July 31, 2003
LIC-03-0104

SUBJECT: Fort Calhoun Station Unit No. 1 "Technical Specifications Updated for NRC Comments on Pending Amendment Request on the Pressure-Temperature Limits Report"

**Marked-Up
Technical Specifications
Updated for Pending Amendment
of the
Pressure-Temperature Limits Report**

Figure 2-1

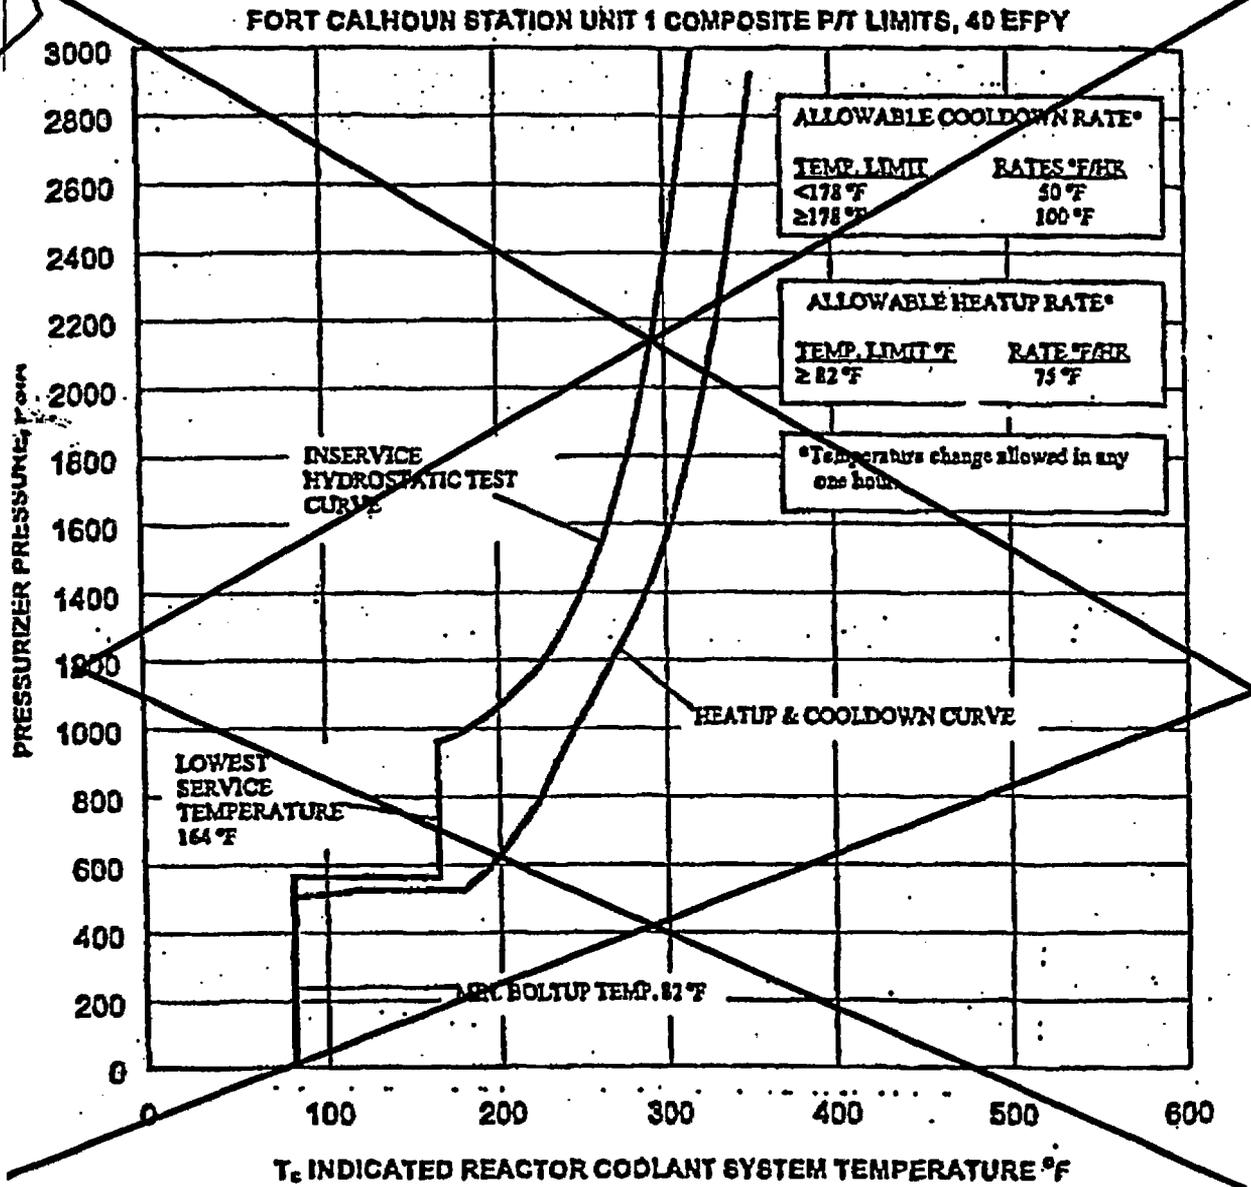
The limit lines in Figures 2-1 are based on Reference 2, Appendix G, W/CE's methodology for P-T limit curve generation¹¹, and ASME Code Case N-640 as discussed below:

The reference stress intensity factor (K_{IR}) used in the development of the limit lines in Figure 2-1 is based on ASME Code Case N-640. This Code case allows the use of K_{IC} (lower bound of static initiation critical stress intensity factor) and is an approved exemption by the NRC in accordance with 10 CFR 50.60(b). K_{IC} is obtained from a reference fracture toughness curve for reactor pressure vessel low alloy steels as defined in Appendix A to Section XI of the ASME Code and is approximated by the following equation:

- 1) Temperature instrumentation uncertainty of 14°F is applied to the entire temperature range of Figure 2-1

- 3) Below 350°F , pressure instrumentation uncertainty is accounted for in the LTOP system setpoints. Above 350°F , a pressure instrumentation uncertainty of 50 psi is applied to Figure 2-1.

The temperature at which the heatup and cooldown rates change in Figure 2-1 reflects the point at which the most limiting heatup and cooldown rates with respect to the inlet temperature (T_i) change.
